PALM BEACH COUNTY
PLANNING, ZONING AND BUILDING DEPARTMENT
ZONING DIVISION

Application No.:	SV/CA-2022-01490
Application Name:	Islamic Center School
Control No./Name:	2022-00007 (Islamic Center School)
Applicant:	Islamic Center of West Delray Beach Inc.
Owners:	Islamic Center of West Delray Beach Inc.
Agent:	Urban Design Studio - Bradley Miller Urban Design Studio - Ailish Villalobos
Telephone No.:	(561) 366-1100 , (561) 366-1100
Project Manager:	Vincent Stark, Site Planner I

Title: a Subdivision Variance **Request:** to allow a reduction in the legal access width on 9.85 acres

Title: a Class A Conditional Use **Request:** to allow an Elementary and Secondary School on 9.85 acres

Figure 3 – Preliminary Site Plan dated (05-18-2023)

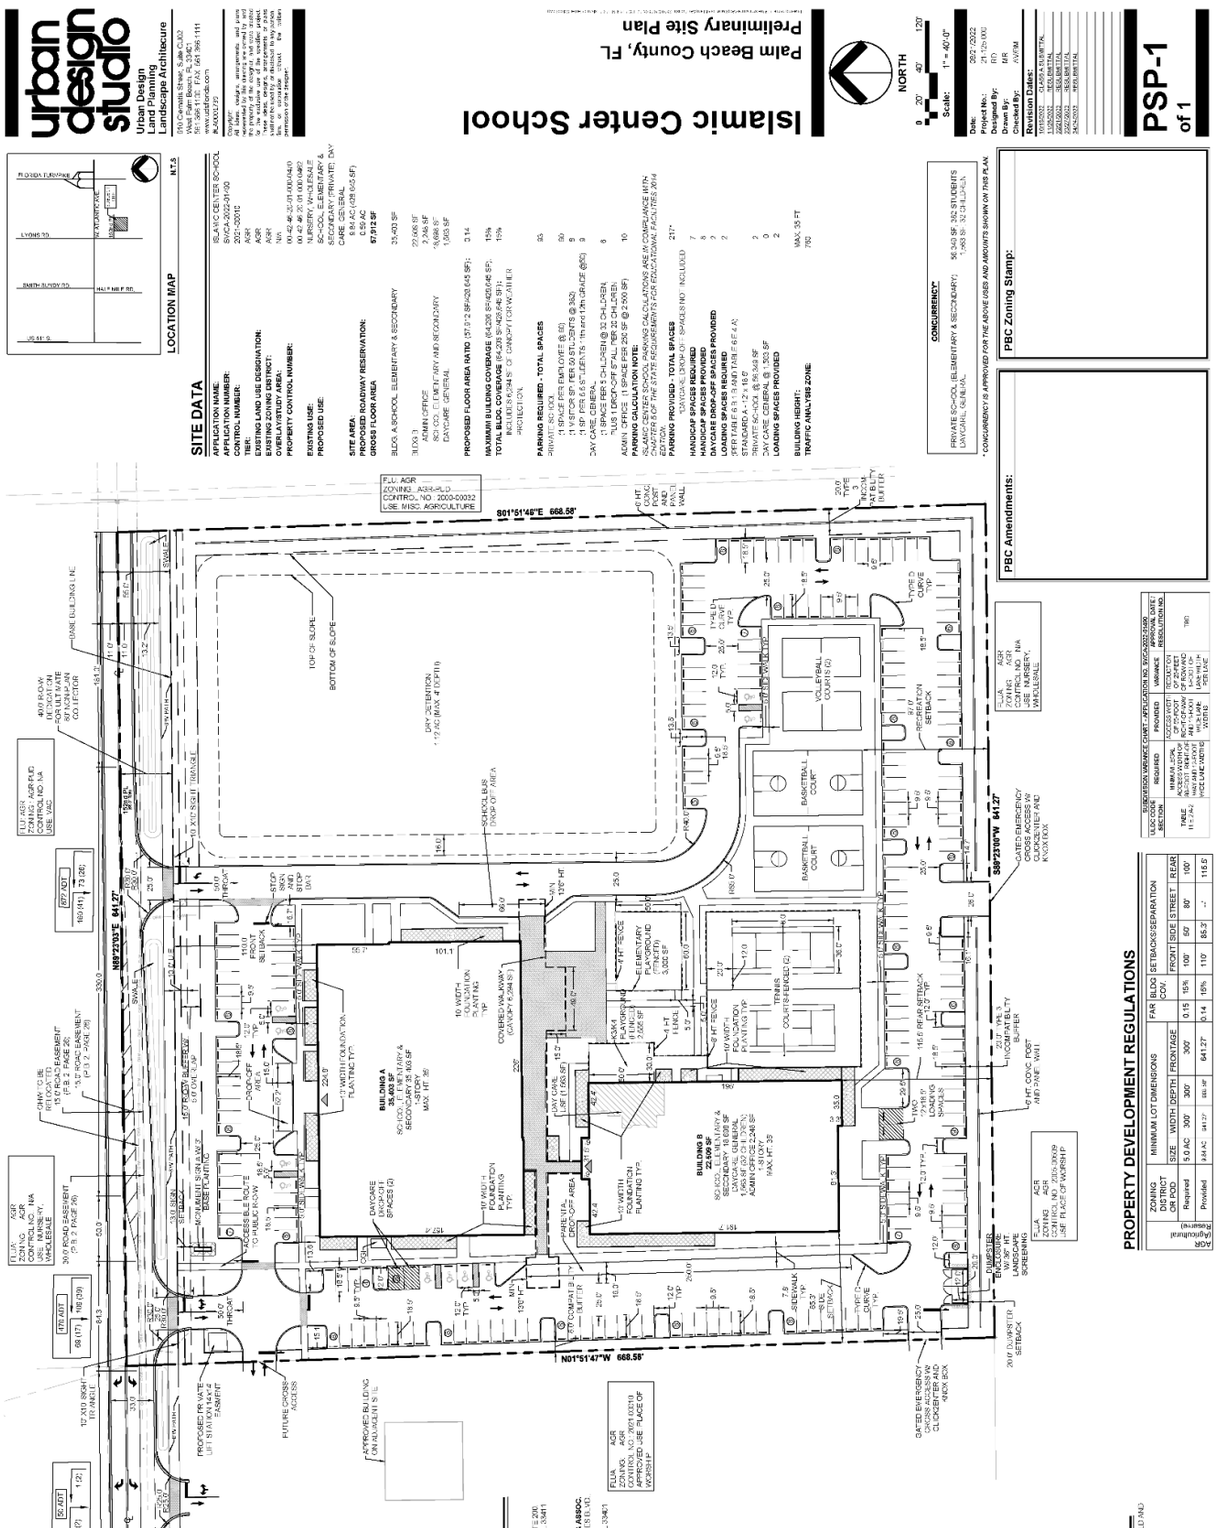
○ *Property Development Regulations:* Table 3.D.1.A Property Development Regulations regulates the required lot dimensions, Building Coverage and minimum setbacks. Staff has analyze the information provided under the Preliminary Site Plan (PSP) and has determine the proposed development is in compliance with the parameters established. The lot meets the minimum size for the AGR Zoning District, 5 acres with a minimum of 300 feet of frontage, width, and depth o. Buildings A and B, meet the required setbacks. The lot frontage and access is from 152nd PL.

- *Parking:* The proposed uses according to Table 6.B.1.B Minimum parking and Loading Requirements required a total of 93 spaces. The Preliminary Site Plan (PSP), indicates a total of 217 parking spaces will serve the site. The proposed site plan is also indicating a total of 2 drop off spaces for the daycare and two loading areas.

- *Landscaping and Buffering*: According to Table 7.C.2.A Regulates the required buffer width and Table 7.C.2.C Incompatibility Buffers. The proposed Preliminary Site Plan indicates a 15-foot ROW (Right-of-Way) landscape buffer along 152nd Place S., and a 20-foot Type 3 Incompatibility Buffer along the eastern and southern property lines, with a 6-foot-high wall. Along the western property line, an 8-foot Compatibility Buffer is provided. The proposed development is in compliance with the required Foundation planting.

1. The approved Preliminary Site Plan is dated May 18, 2023. Modifications to the Development Order inconsistent with the Conditions of Approval, or changes to the uses or site design beyond the authority of the Development Review Officer as established in the Unified Land Development Code, must be approved by the Zoning Commission. (ONGOING: ZONING - Zoning)

Figure 6 – Pickup/Drop-off Operations Diagram

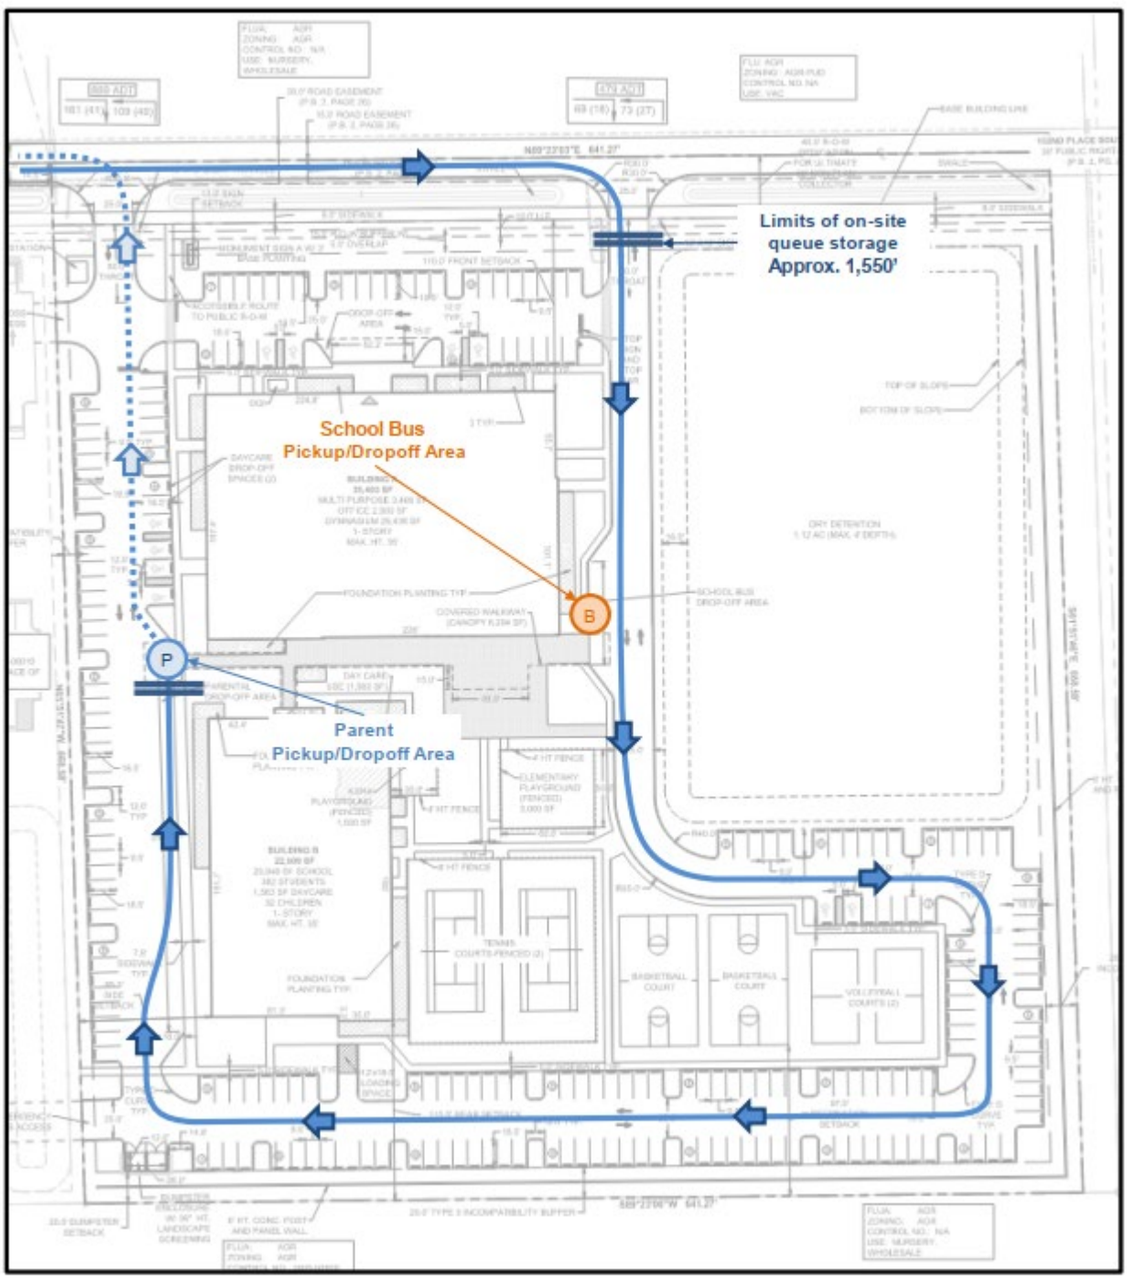
The Private Elementary School as indicated on the Preliminary Site Plan occupies a total of 56,349 sq.ft. located within two separate buildings with 382 students. In addition the Applicant has provided a Pickup/Drop-off operation diagram that indicates their entrance along the eastern portion of the Site and circle on a one way loop through the site (Exhibit 6)
